1.2 Connected and Integrated

Rights of Way Network

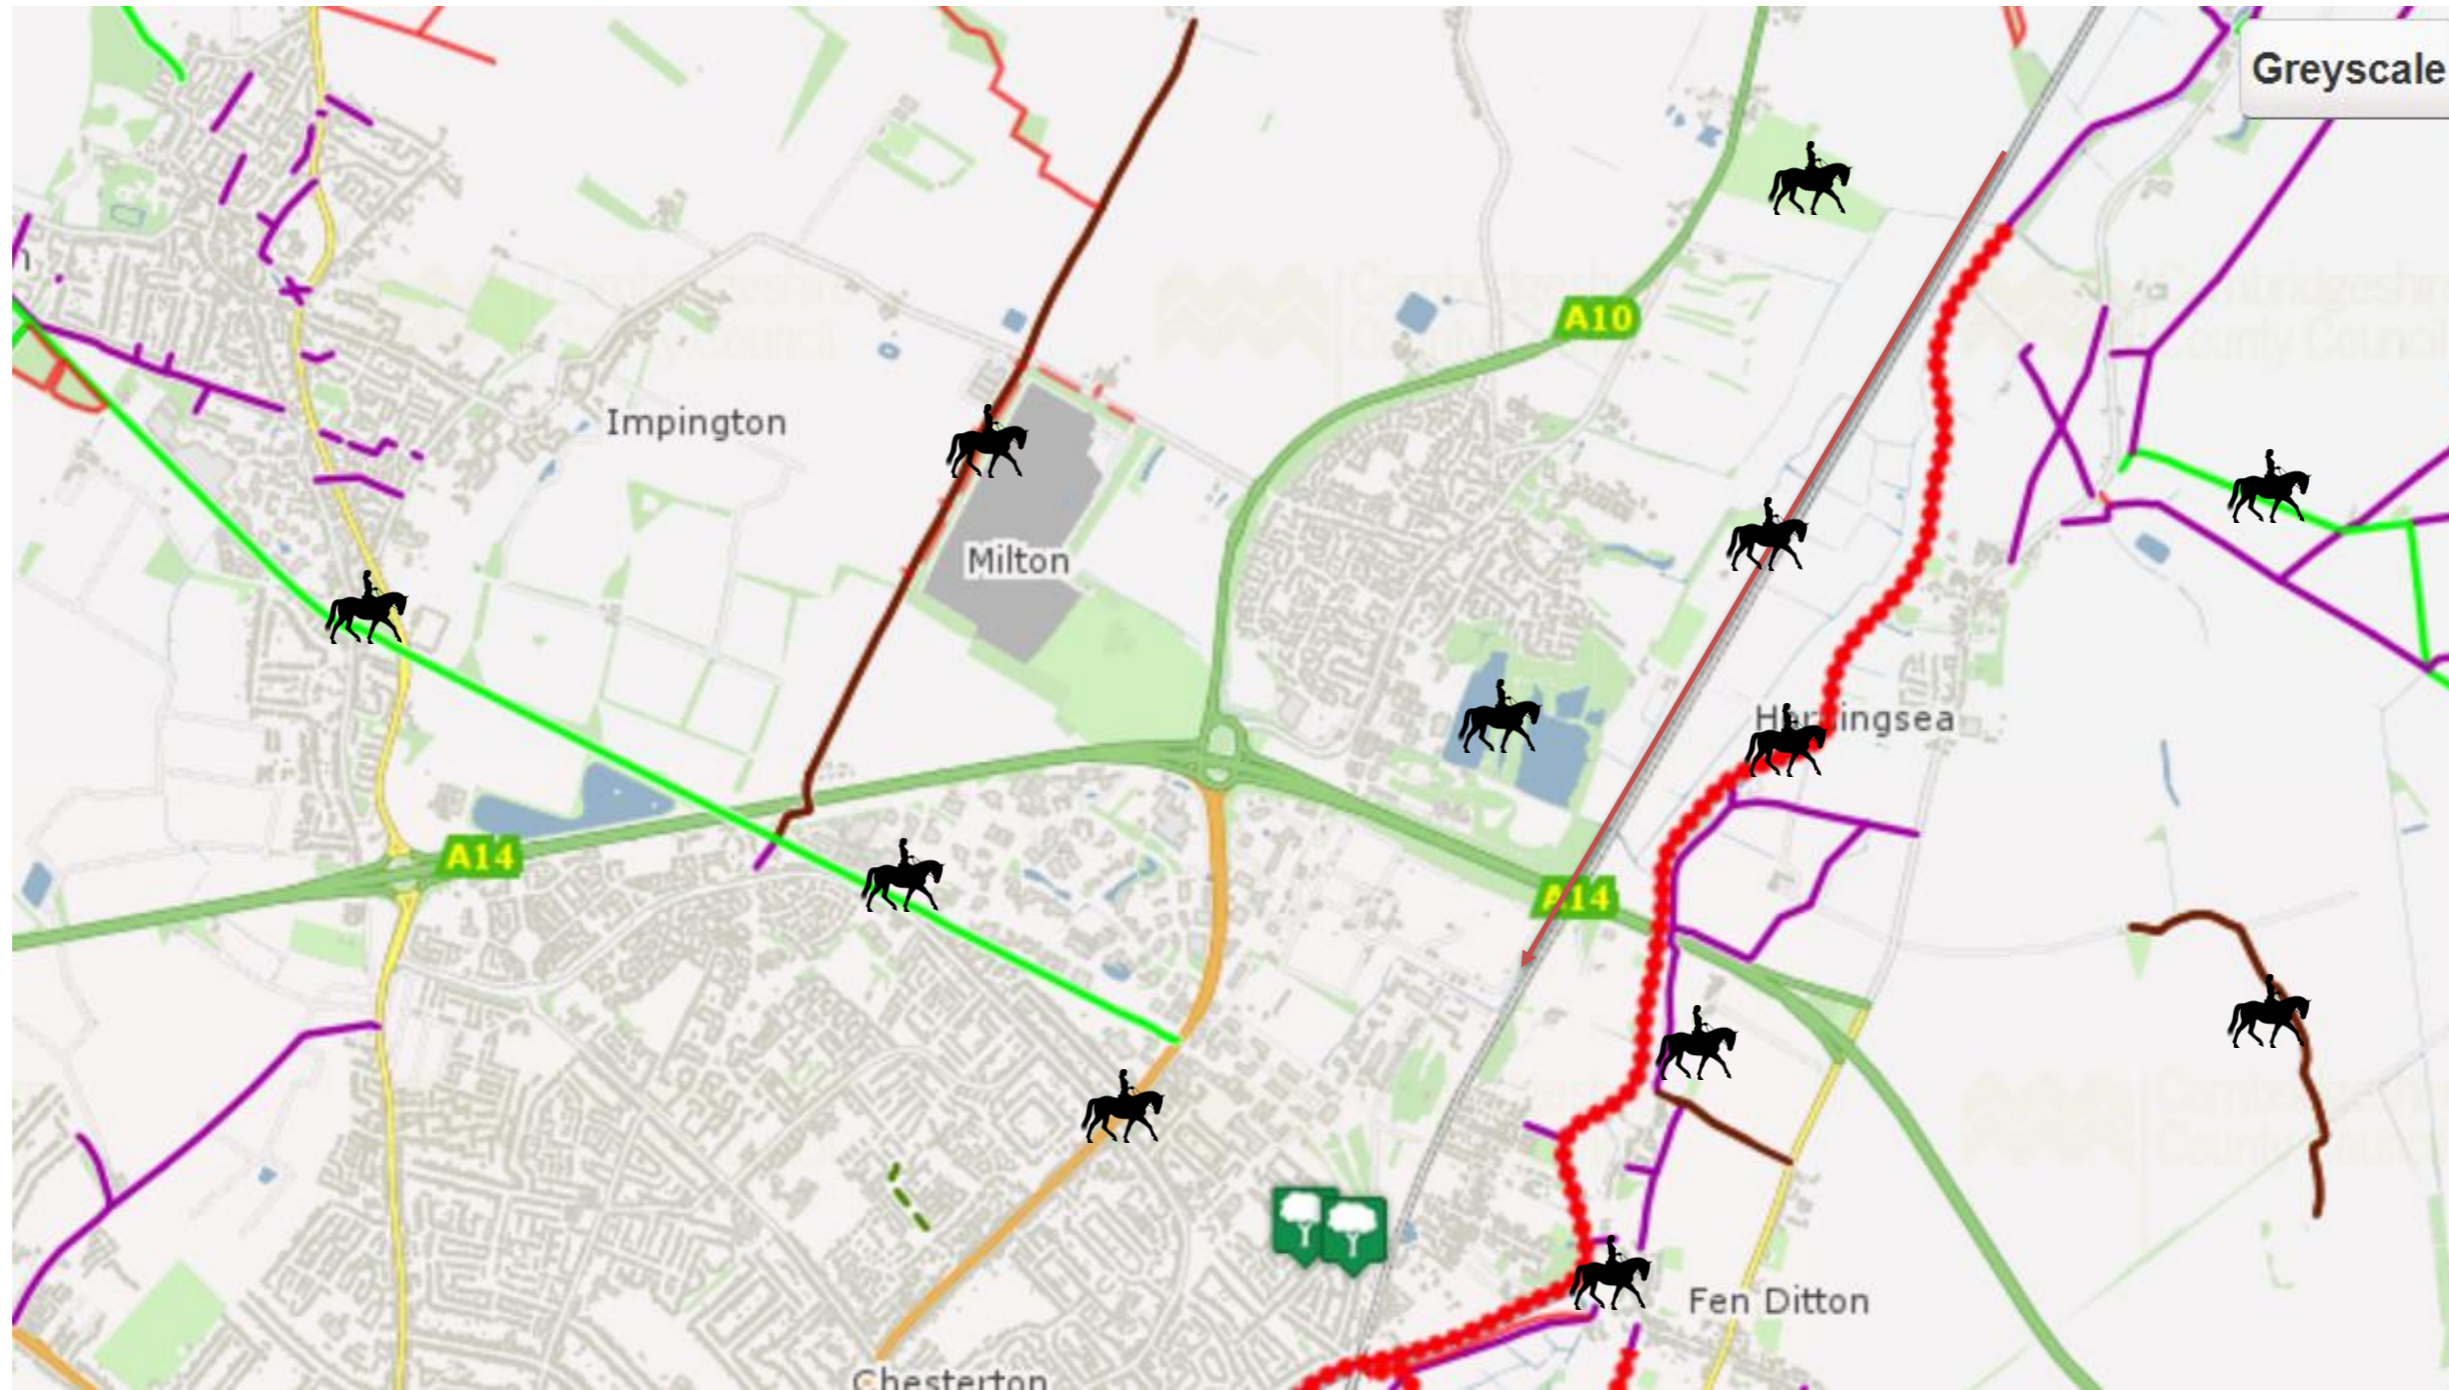
Complete failure to recognise and include existing RoW and current equestrian communities and access.

Incorrect labelling of RoW.

No inclusion of equestrian access opportunities in project.

Routes have been erroneously claimed as 'cycleways' when they are
bridleways (green), byways (brown), omitted (Greenway project) which are NMU's.

Some restrictive cycleways are to be challenged.
